PLANNING AND ZONING COMMISSION MEETING

**PARKSIDE HILLS - 5TH ADDITION - LOT 1
SITE PLAN REVIEW**

PARKSIDE HILLS - 5TH ADDITION - LOT 1

OVERALL LAYOUT PLAN

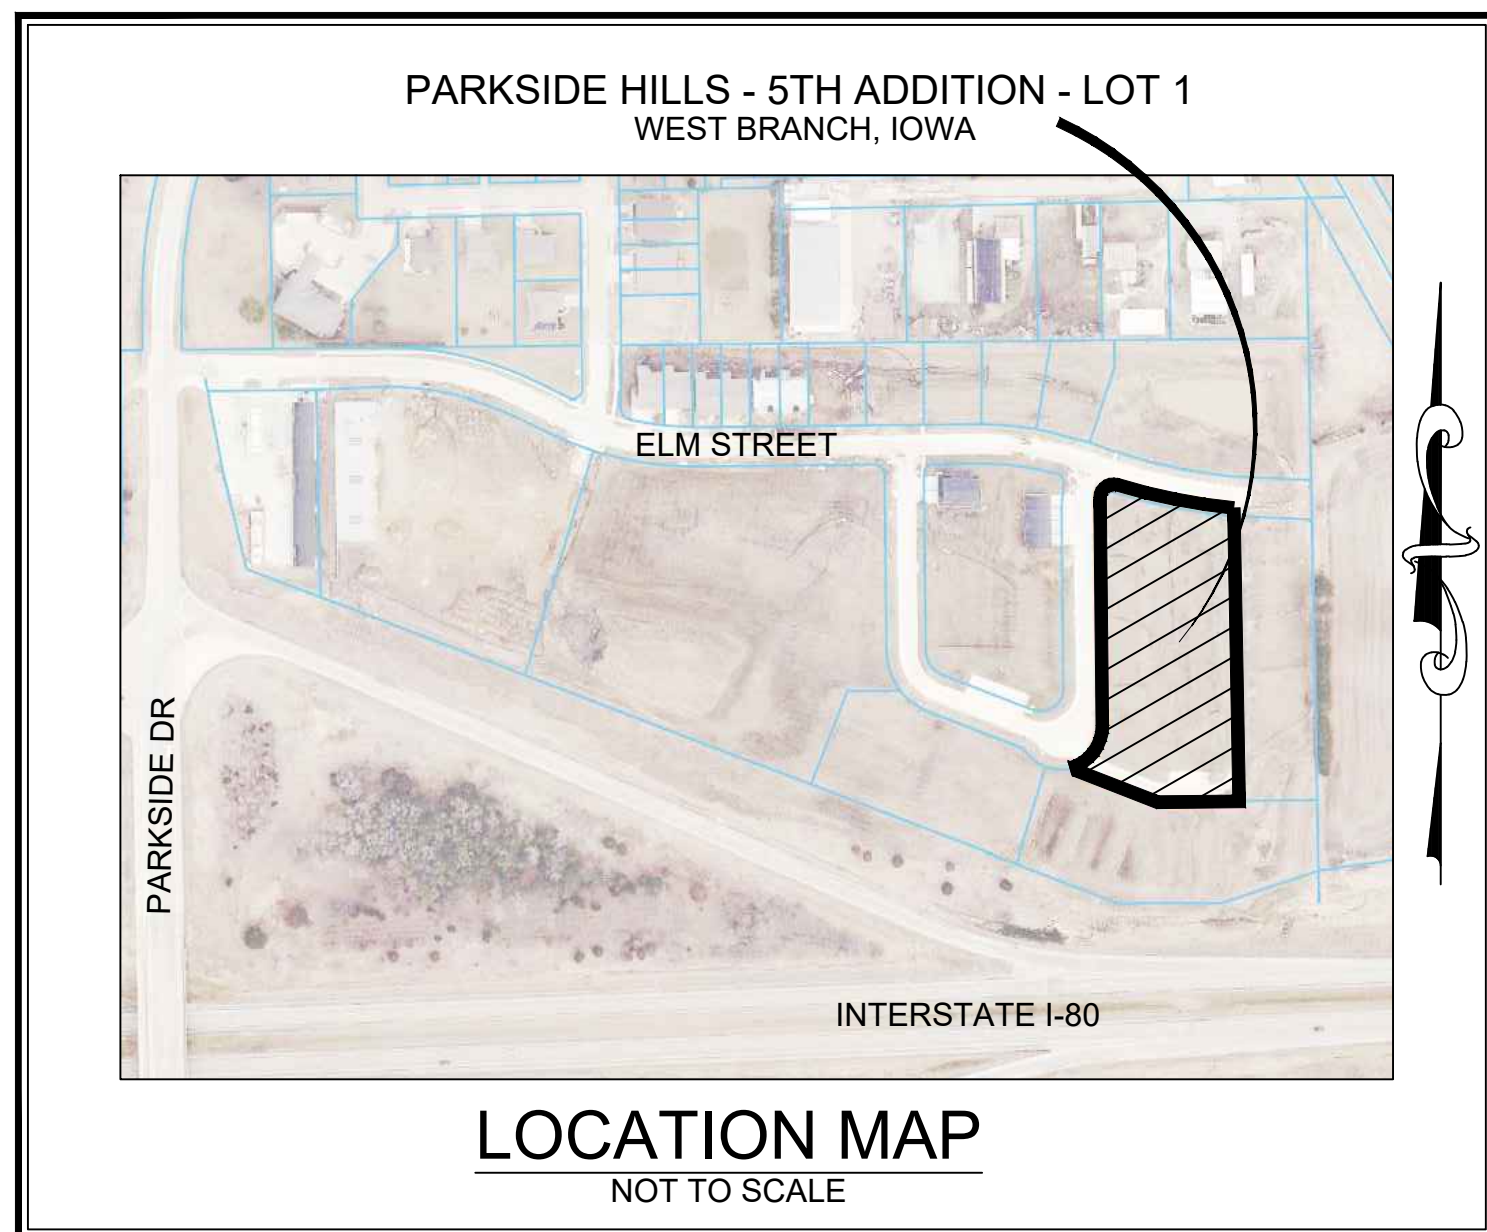
1. Indicate if lighting will be included in the carport area.
2. Parking requirement table lists 18 two bedroom units with 27 spaces required. Correct table to show 36 spaces required for two bedroom units and 81 spaces for total parking required. (noted that 99 spaces provided exceeds 81 spaces required)
